PROJECT 3019
Reviving the Heart of Pittsburg Pride
ADDENDUM NO. 1

ITEM 6 – DRAWING REVISION: SHEETS L1.1, L3.2, L3.7, & L5.21

DWG. NO.
L3.2

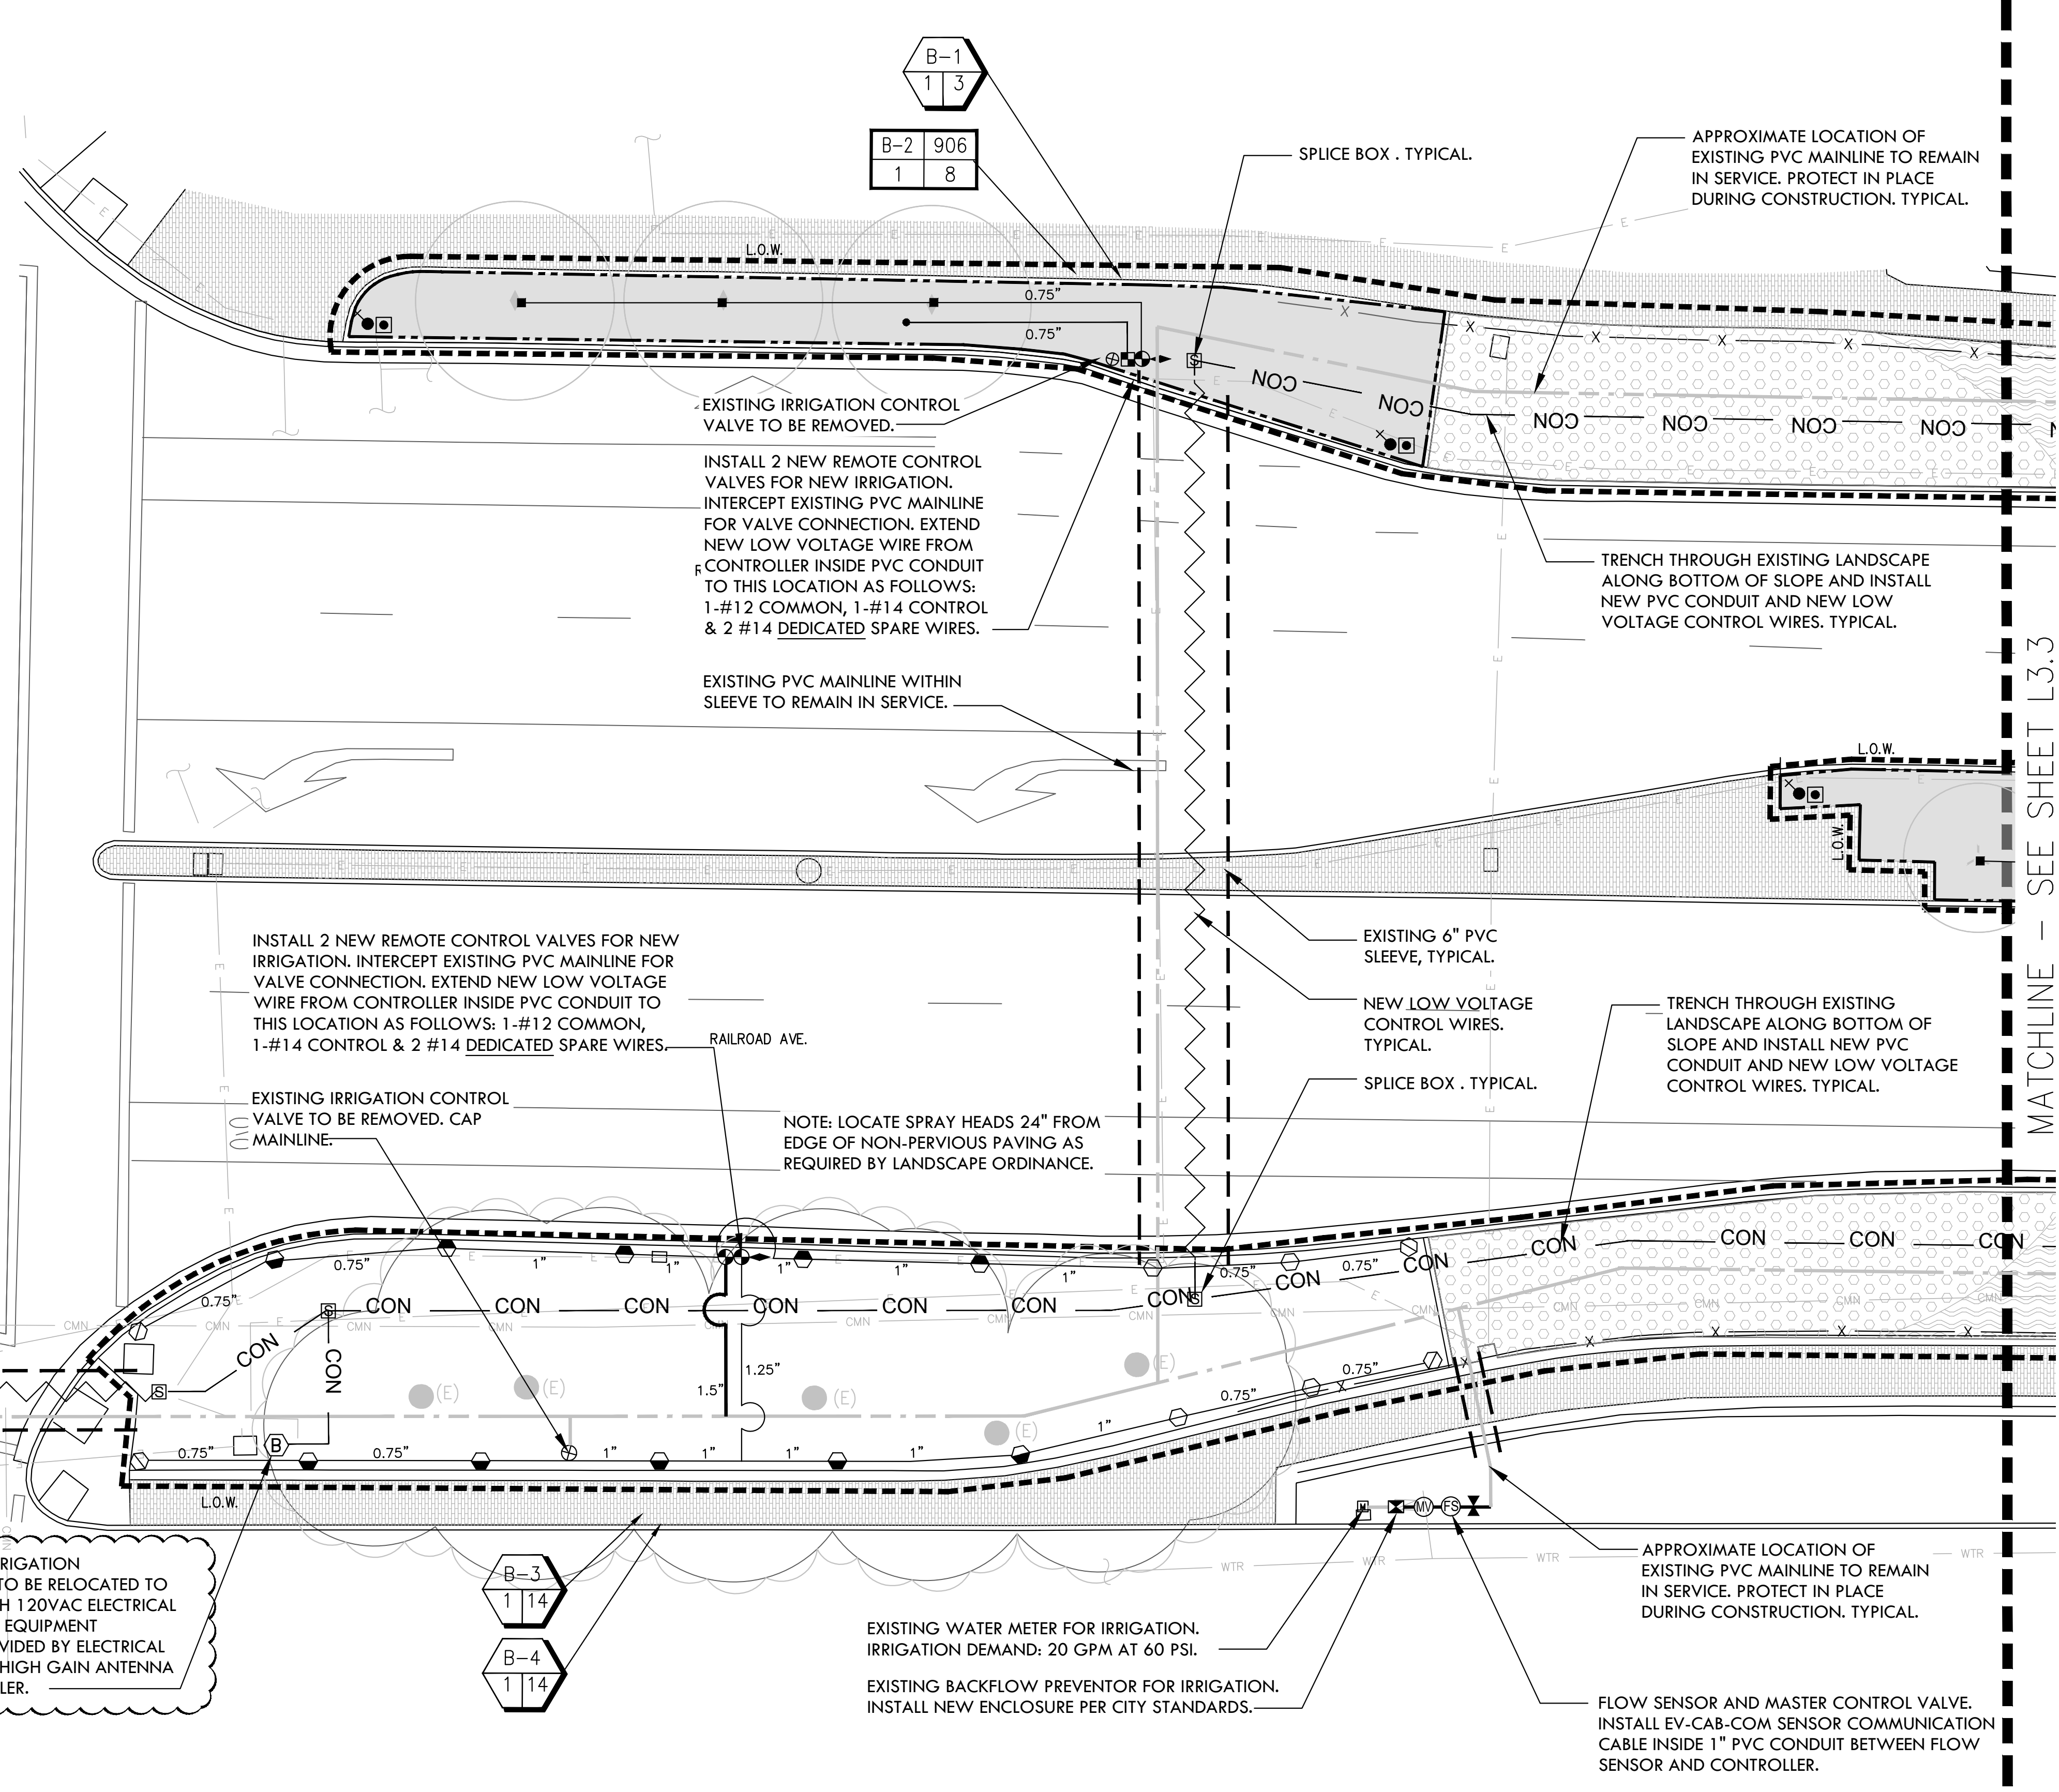
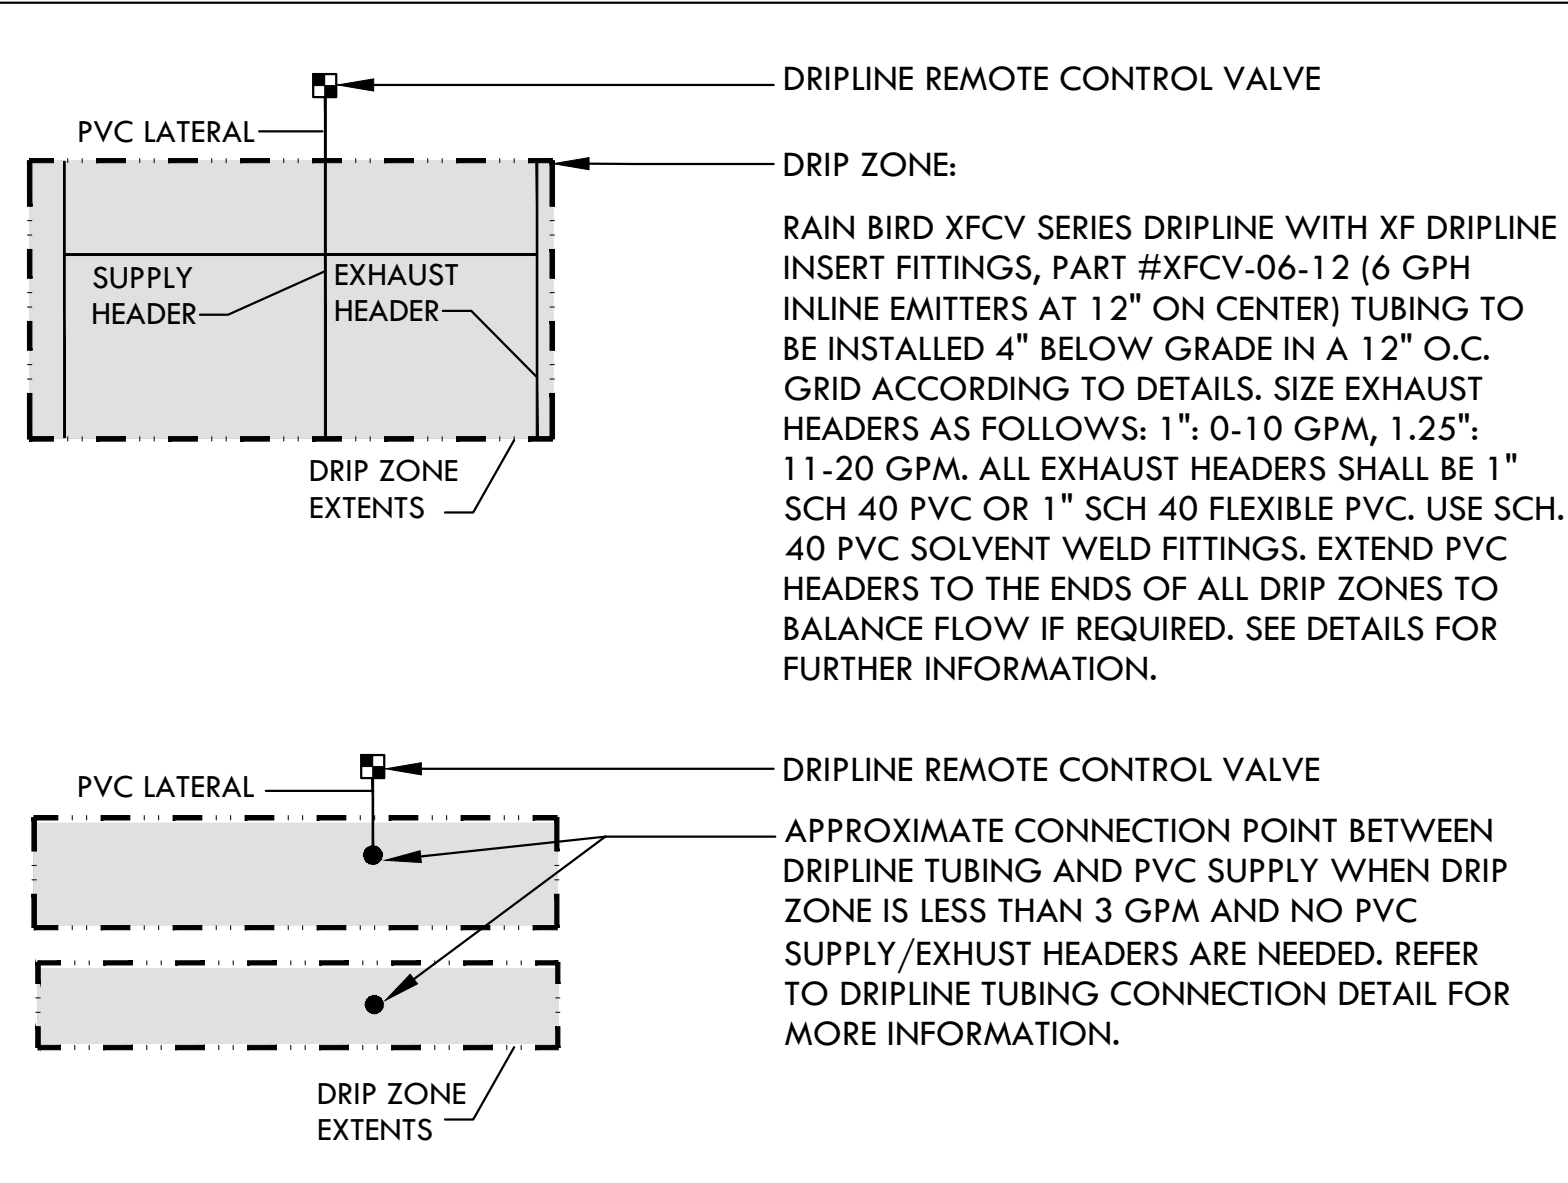
Clarification to advise that the PVC conduit and low voltage wire replacement shall be as indicated on the irrigation plans. Existing stations available at controller “A” are unknown, but not required as all of the existing valves at the non-irrigation slope areas will not require new wire replacement.
